Water of Leith Flood Prevention Scheme – Phase 2 Stakeholder Engagement Group 26 January 2016 Response to Actions Arising

Appendix A Roseburn Park – Tree Removal Response to Discussion at Stakeholder Engagement Group Meeting 26 January 2016

Comparison between Planning Drawing and Tender Drawing

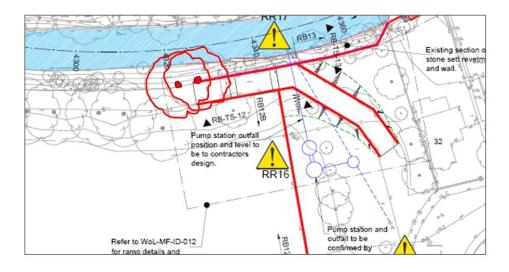
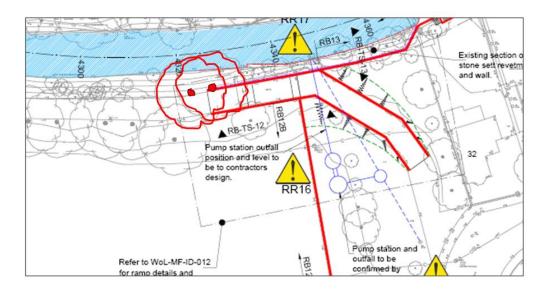
The following shows the relevant extract from Planning Drawing No. 69240-I5 B

The following shows the relevant extract from the Tender Drawing No. WoL-MF-DA-004 (The trees of concern are highlighted in red)

The start of the ramp is at the same river chainage on both the planning and tender drawings clearly demonstrating that the design has not changed.

Of the two trees the downstream one sits directly under where the ramp is to be constructed and must be felled.

The most upstream one is very close to the construction works and the roots may be severed and prudence requires that it also needs to be felled.

However, the Contractor has advised that he will make his best efforts to retain this tree and it will not be felled prior to finalising the design and construction details in the area. If it transpires that it cannot be retained it will be felled in the next period available outwith the bird nesting season (September 2016 to February 2017)
